**World Forum for Harmonization of Vehicle Regulations****Working Party on Pollution and Energy****Sixty-second session**

**Heavy duty vehicles – Regulation No. 49****(Emissions of C.I. and P.I. (NG and CNG) engines)****Proposal for an amendment to Regulation No. 49****Submitted by the expert from the European Commission \***

The text reproduced below was prepared by the expert from the European Commission (EC) to introduce amendments to Annexes 9 B and 9C of Regulation No. 49. This document proposes amending the provisions of the Regulation to clarify a number of concerns identified by the experts from EC during the preparation of legislation implementing the Euro VI emission levels (i.e. Regulation (EC) 595/2009).

Figure 4, amend to read:

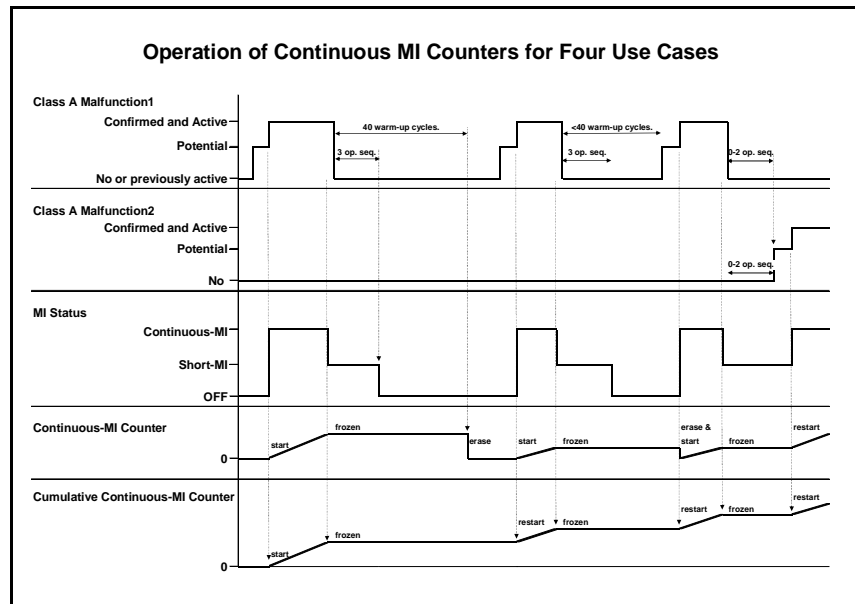
**Note:** Details related to the deactivation of the continuous MI are illustrated in figure 4bis below in the specific case where a potential state is present."

Details of this mechanism are illustrated in a new figure 4bis, but figure 4 needs to be modified accordingly.

"Figure 4bis: Illustration of the continuous MI deactivation principle

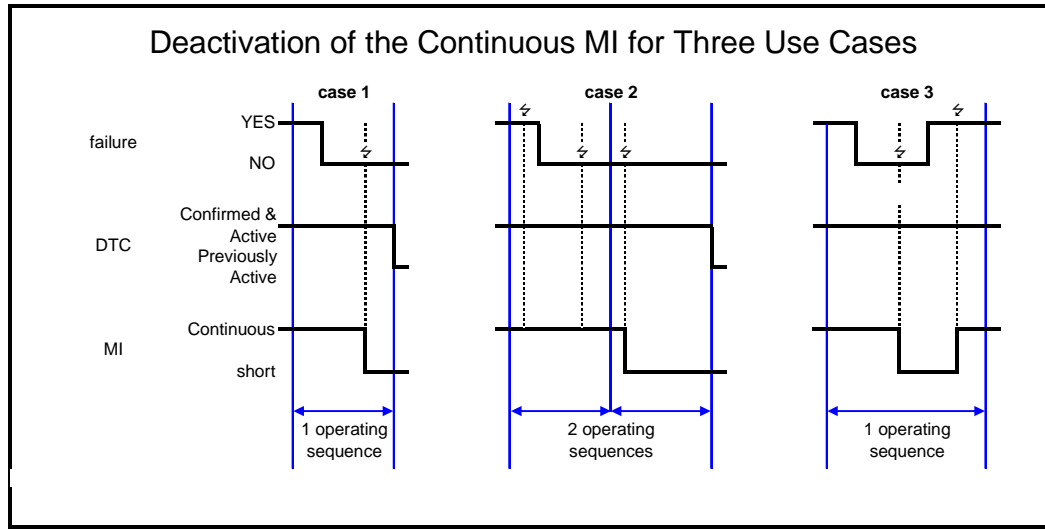
A new figure 4bis is introduced, to read:

- (b) The continuous MI is deactivated as soon as the monitor has concluded the absence of the malfunction. On the contrary, the status of the malfunction changes from confirmed and active to previously active at the end of the operating sequence.

This new figure aims at illustrating the continuous MI deactivation scheme in 3 typical cases and at reinforcing the consistency between the figures and paragraph 4.6.3.1.4.
